- 3.1 Lot 9501, No. 32 Meares Avenue, Kwinana Town Centre - Proposed Drive-In Takeaway Food Shop (McDonalds)– DAP/25/02957

**Part B – Item 3.1 - LOT 9501, NO. 32 MEARES AVENUE
KWINANA TOWN CENTRE. PROPOSED DRIVE-IN TAKEAWAY
FOOD SHOP (MCDONALDS).**

**Form 1 – Responsible Authority Report
(Regulation 12)**

Figure 3 – Master Plan Precinct Plan and Subject Site

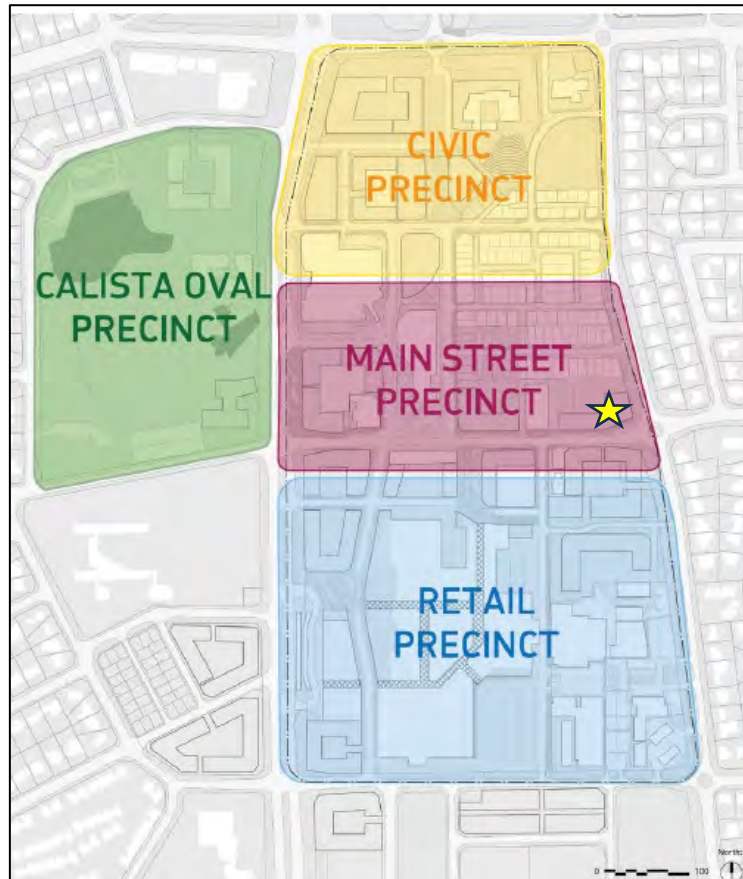
1. The application includes a key divergence from the aims of the Master Plan for Chisham Avenue by setting the building back from the street boundary due to the placement of the drive-through lanes, rather than facilitating a built edge and active frontage along the street.
4. The proposed development does facilitate activity outside of business hours as it proposes 24 hours a day, seven days per week operating hours.
5. As the application proposes a drive-through facility that is likely to be highly utilised, the evaluation of traffic impacts on the local road network require due consideration.

The proposed development is generally consistent with the vision, objectives, concept and design guidance of the Master Plan with the notable exception of the proposed building's setback not aligning with the street frontage of Chisham and Meares Avenue.
